WASHINGTON METROPOLITAN AREA TRANSIT AUTHORITY  
600 FIFTH STREET, N.W.  
WASHINGTON, D.C. 20001

AMENDMENT NO. 4  
TO  
REQUEST FOR PROPOSALS  
FOR  
REHABILITATION OF WMATA PARKING GARAGES AT SHADY GROVE (NORTH), FRANCONIA-  
SPRINGFIELD (EAST), GROSVENOR-STRATHMORE AND COLLEGE PARK  
FQ15090/GG

The Invitation for Bid for IFB FQ15090/GG requesting Bids for the above project is hereby changed in part as listed below.

DRAWING NO.  
A15P-S-001

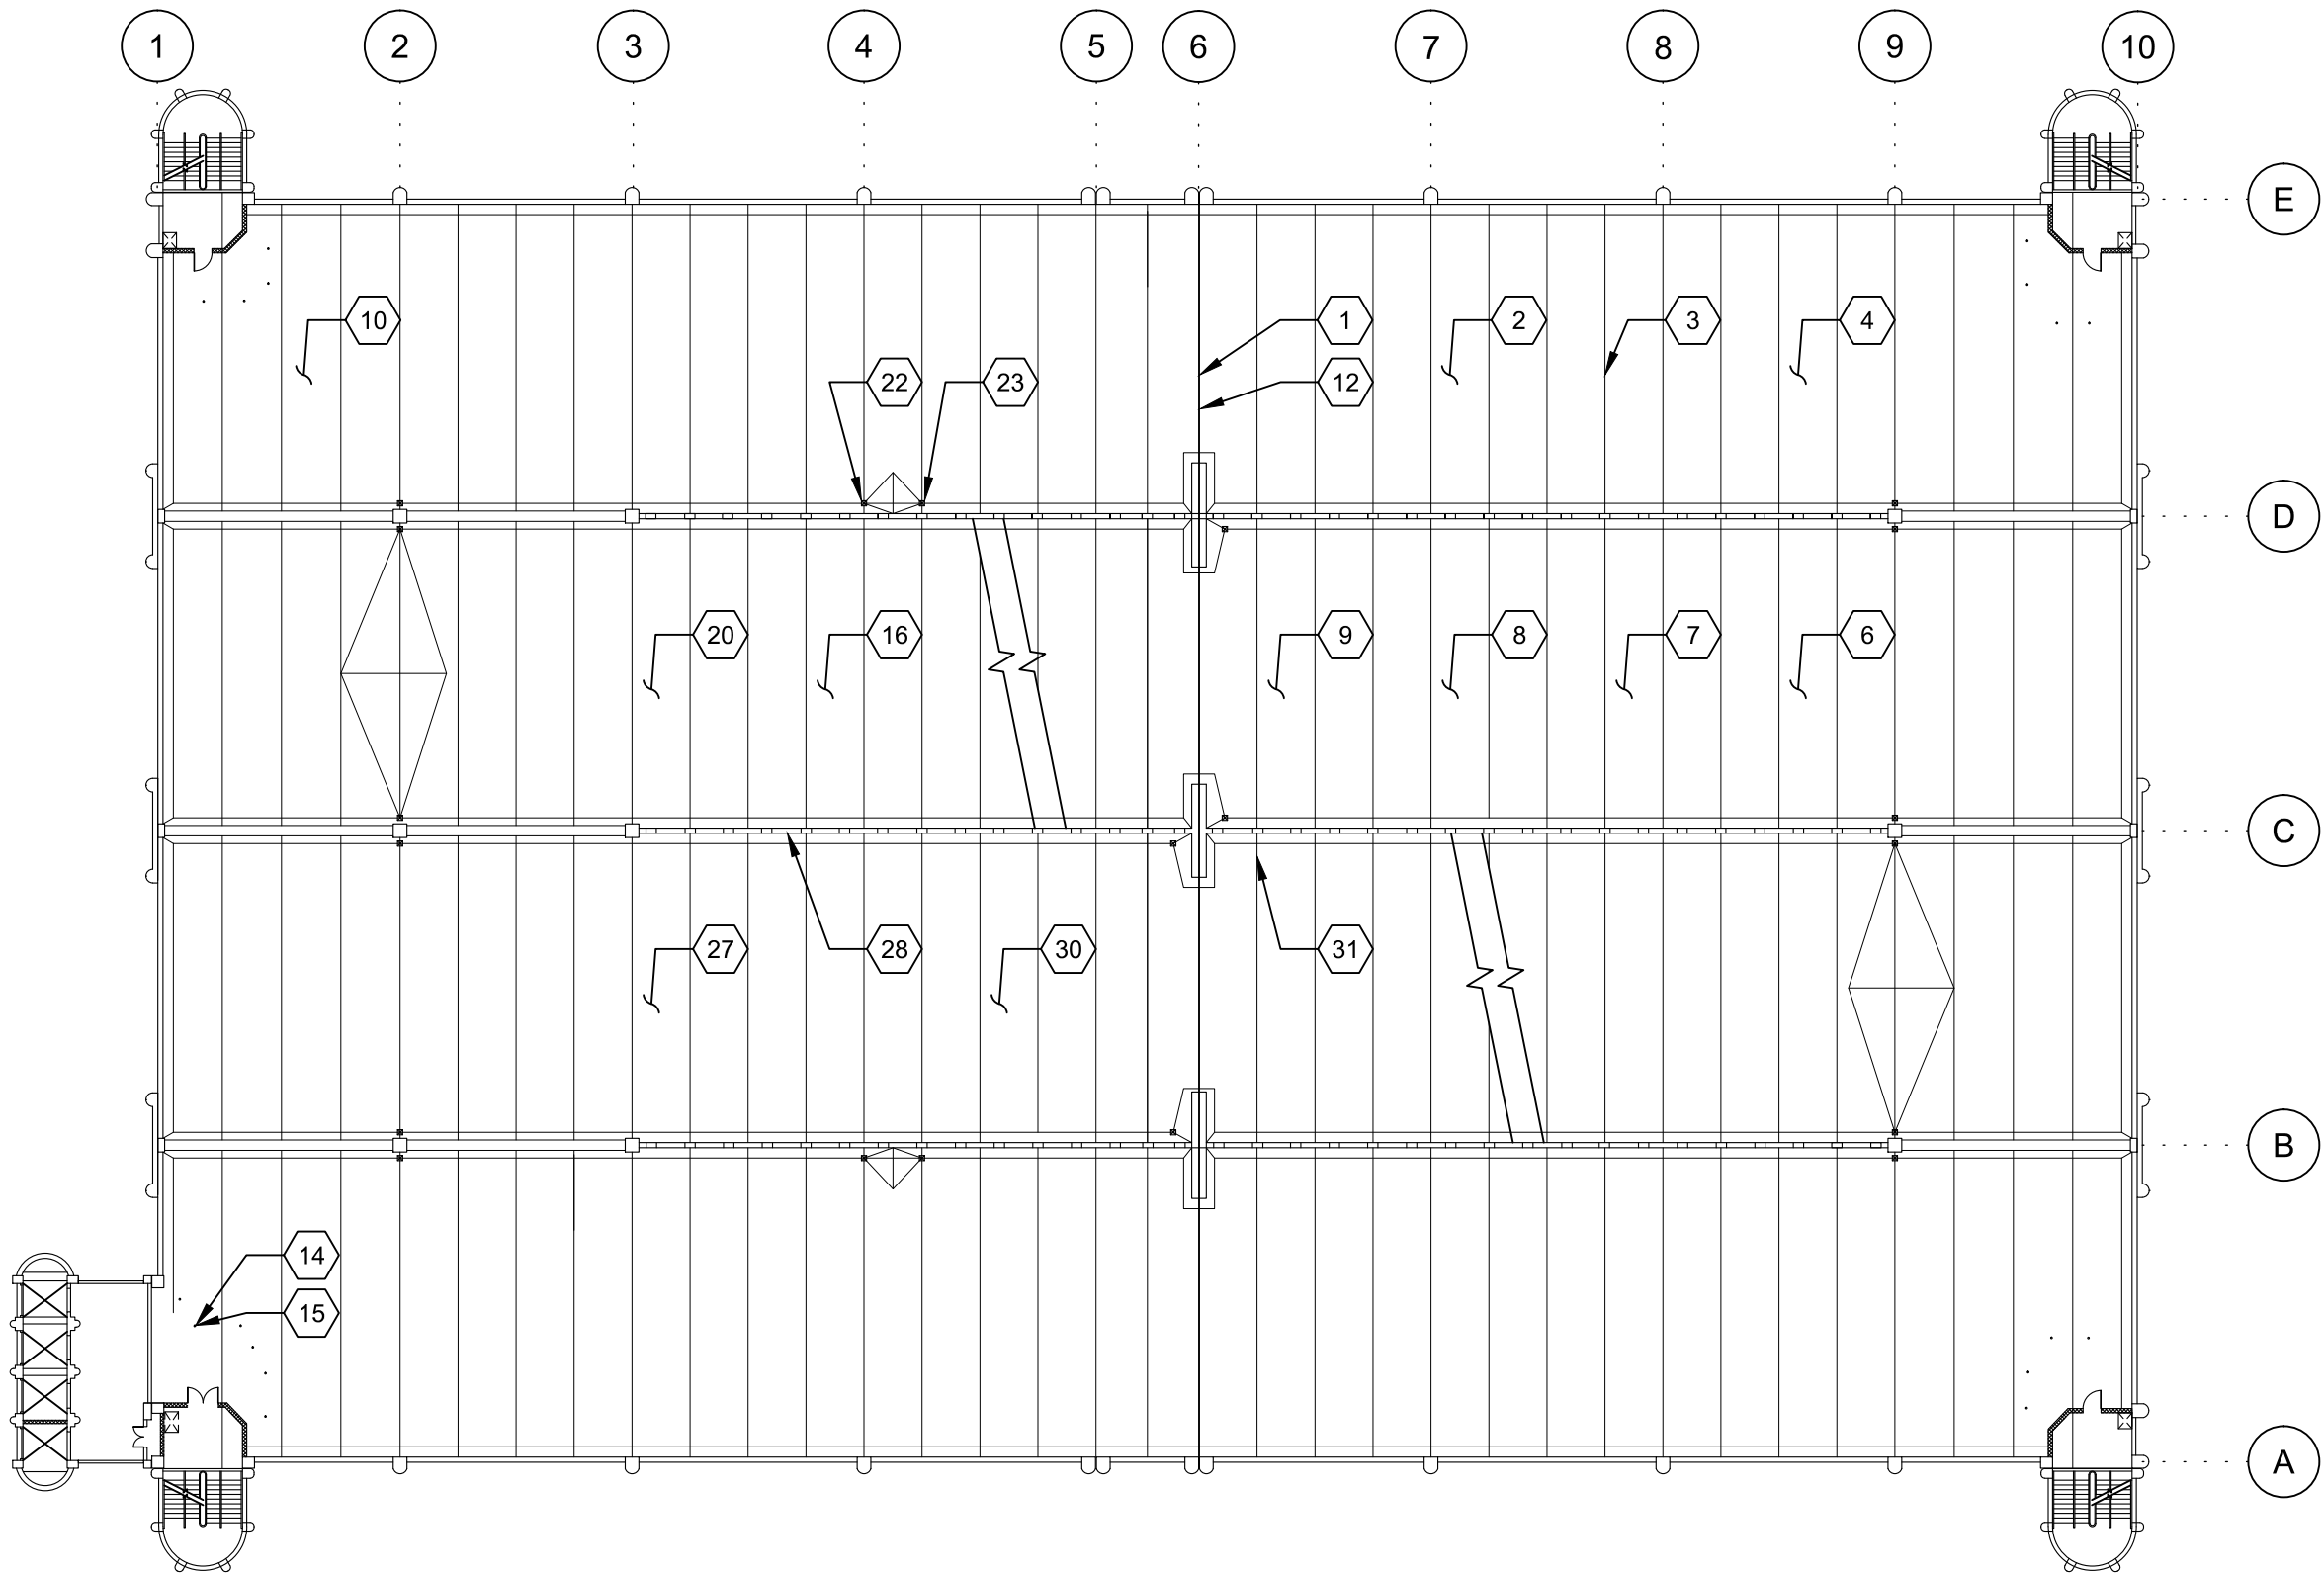
- AM 3
- 8
- REMOVAL AND REPLACEMENT OF DETERIORATED AND SOUND CONCRETE AT DOUBLE TEE BEAM WEB WITH EXPOSED REINFORCEMENT AS PER DETAIL 3/S-513 (APPROX. 35 SF).

- AM 4
- 19
- REPAIR OF DOUBLE TEE FLANGE CONNECTION TO WALL AS PER DETAIL 1/S-514 (APPROX. 1 LOC).
- AM 3
- 20
- POWERWASH SEEPAGE AREAS AT UNDERSIDE, AS PER SPECIFICATIONS (APPROX. 661,000 SF).

- AM 3
- 29
- REPAIR OF BROKEN CORNER OF DOUBLE TEE FLANGE AS PER SHEET S-512 (APPROX. 6 LOC).
- AM 3
- 30
- CLEANING AND PAINTING OF EXPOSED STEEL (APPROX. 70 SF).
